UNITED STATES PATENT AND TRADEMARK OFFICE

Office Action Summary	Application No. 10/663,755	Applicant(s) SMITH, STERLING	
	Examiner Hiep Nguyen	Art Unit 2816

DETAILED ACTION

Fig 3

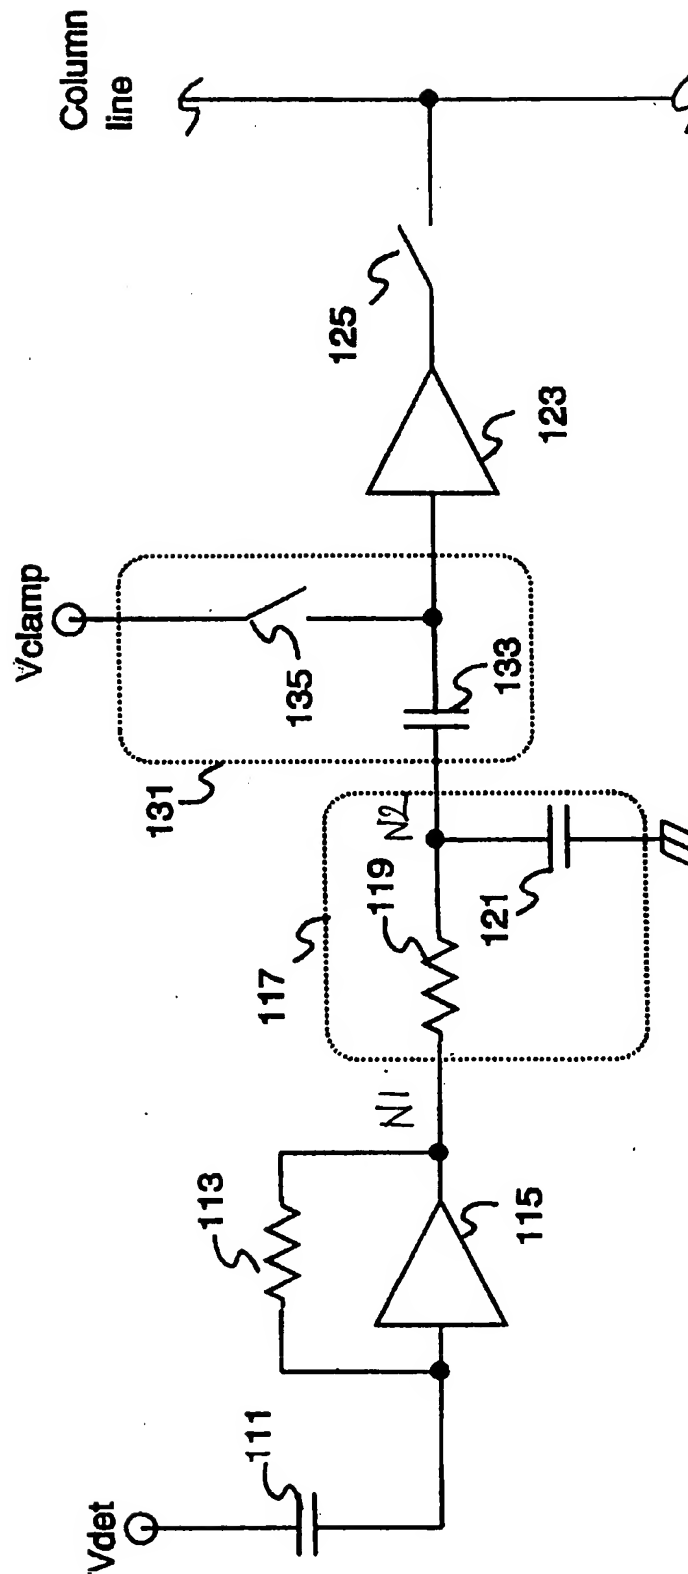
Claims 19 and 23 are rejected under 35 U.S.C. 102(b) as being anticipated by Peterson et al. (US 5,926,217). See attachment.

Regarding claim 19, figure 3 of Peterson shows an electronic circuitry, comprising: a first capacitor (111) for capacitively coupling an analog image signal (Vdet) to a first node (N1); a resistor (119) electrically connected between said first node (N1) and a second node (N2); a second capacitor (121) electrically connected between said second node (N2) and a ground node; and a switching device (135) connected between said second node and a reference level (Vclamp); wherein said resistor and said second capacitor form a filter for processing said analog image signal and providing a processed image signal at said second node, and said switching device is controlled by a clamping signal, not shown, to clamp said second node at a clamping voltage (Vclamp) with reference to said reference level during a clamping interval. The switching device (135) that is equivalent to the switching device (M9) in figure 4 is a transistor having a drain connected to the internal node, a source connected to the reference voltage and a gate controlled by a clamping signal (Vclmp).
